L-2004-029  
10 CFR 50.90

RE: St. Lucie Units 1 and 2  
Docket Nos. 50-335 and 50-389  
Supplemental Information to  
Spent Fuel Pool Cask Pit Rack Amendments

## **SPENT FUEL STORAGE EXPANSION**

**ST. LUCIE UNITS 1 AND 2**

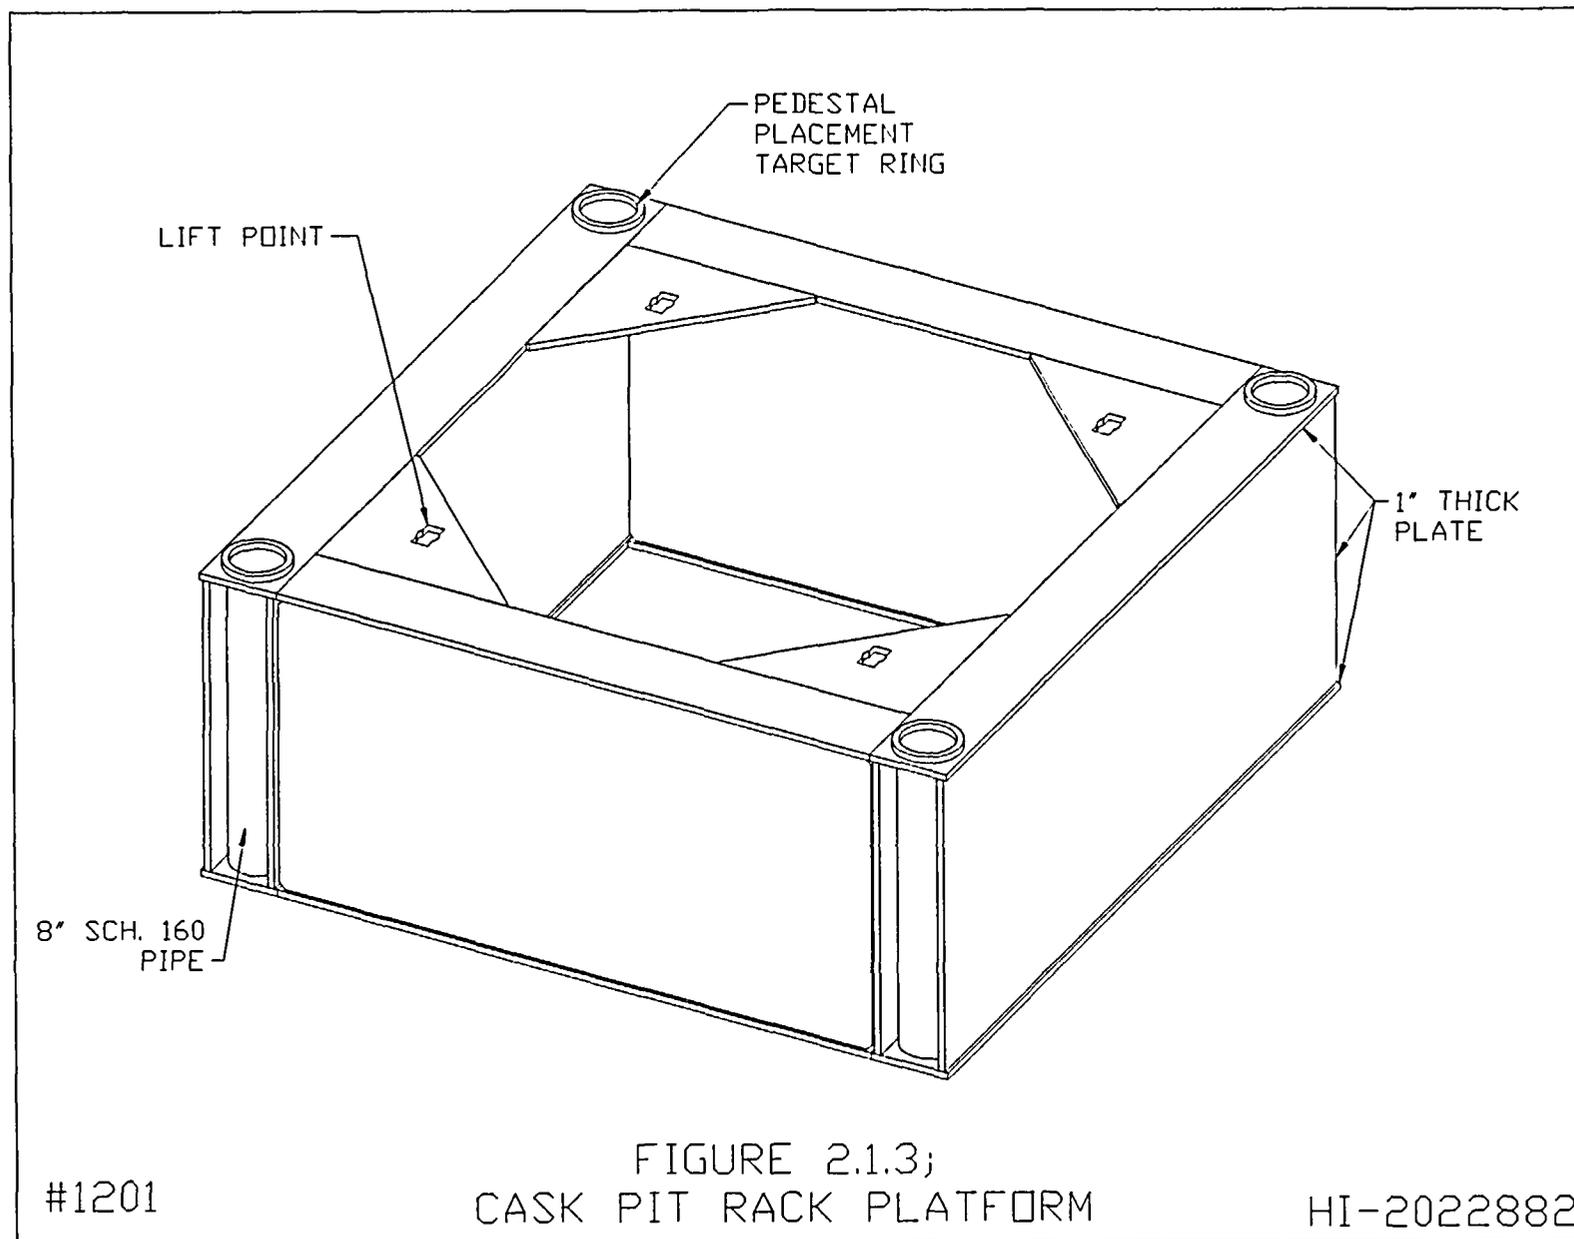
Corrected reference numbers on the following pages 4-3, 4-4, 4-16, 4-17, 4-18, 6-35, 8-15. Adjusted fuel rod diameter tolerance for CE fuel in Table 4.1.4.1. Revised fuel weight discussion in Section 6.3.1. Removed proprietary designation from footer of Appendix 4A. Corrected baseplate hole diameter on pages 2-12, 2-15, and 2-16. Corrected cell inside dimension on page 2-15. Revised proprietary information highlighting designation on pages 6-23 and 6-24. Adjusted text on pages 2-14, 2-15, 2-16, 3-5, 5-22, 6-31, 6-32, 6-34, 7-1, 7-2, 7-5, 7-8, and 8-1 to address revised rack cell and platform heights and weights. Corrected Figure 2.1.3 to reflect revised rack platform lift point configuration.

The elevation of the Cask Pit floor liner in each Unit is approximately three feet lower than the floor liner in the adjacent spent fuel pool. Between the rack module pedestals and the Cask Pit floor liner is a rack platform, which serves to lift the new rack to the SFP rack height, and to diffuse the dead load of the loaded racks into the reinforced concrete structure of the pit slab. The height of the platform is designed to adjust the top of rack height to the same level as the racks in the adjacent spent fuel pool. A schematic view of one of these platforms is shown in Figure 2.1.3.
